## ADDENDUM NO. 1

### REQUEST FOR PROPOSAL ON-BOARD AUTOMATED PASSENGER COUNTERS (APC) SYSTEM FOR BUS FLEET

RFP NO.: 2020-FP-01

Date Issued: February 20, 2020

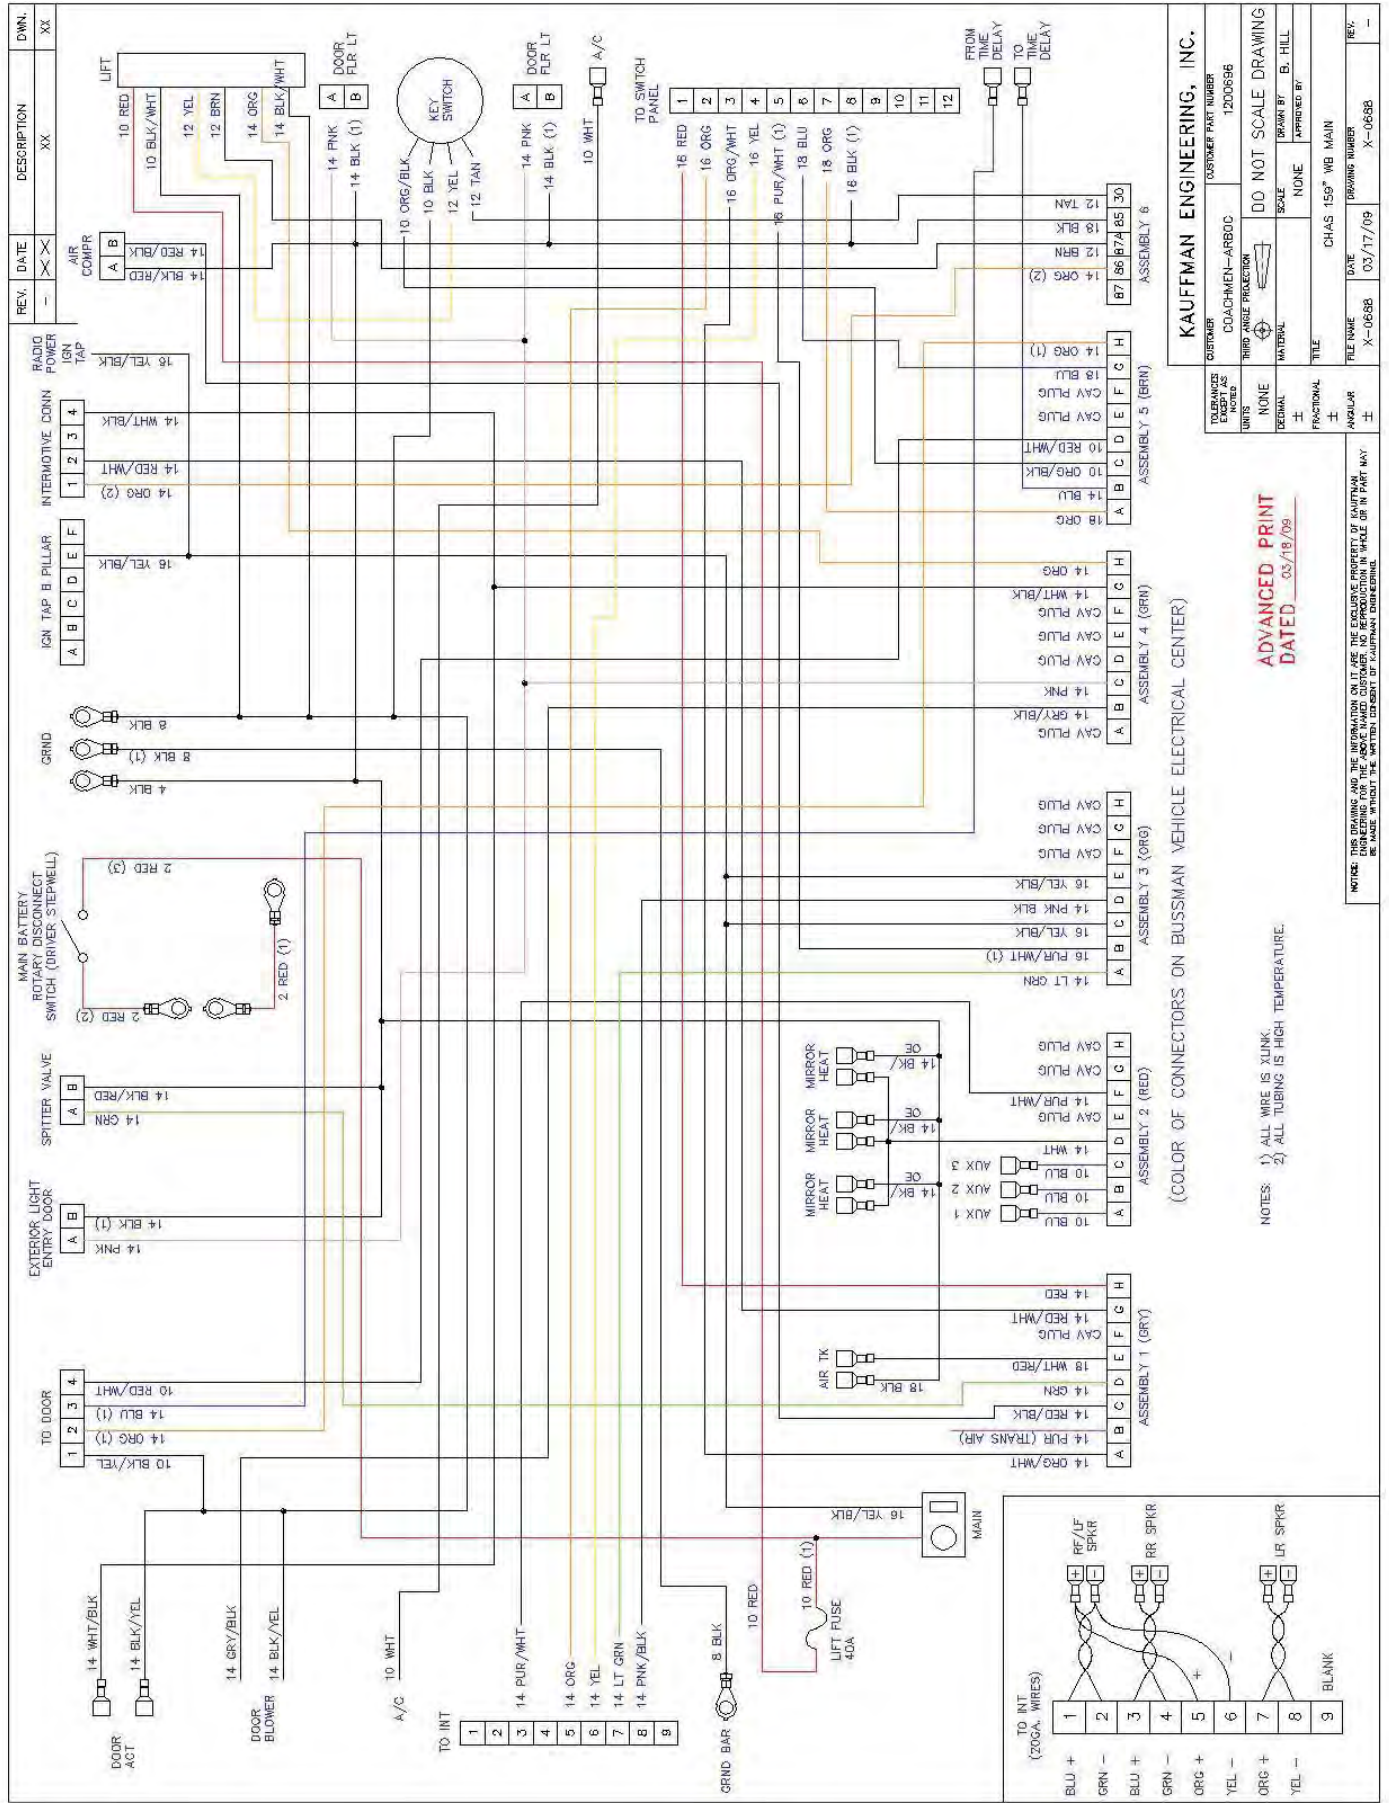
- a. Would CCRTA be able to provide wiring/connection diagrams for bicycle racks and wheelchair ramp sensors and communication equipment on each bus type?
- b. Can CCRTA confirm that the wheelchair and door sensors are wired?

Response: A. Both bus types Electric Diagrams are attached.  
 B. Yes, Both wheelchair ramp and bike rack sensors are wired for the normal bus operations, but the vendor will be responsible for determining effectiveness and suitability for APC use. The Vendor must ensure the use of existing sensors does not affect current operations. Note that the wheelchair sensors interface with the bus safety interlock system.
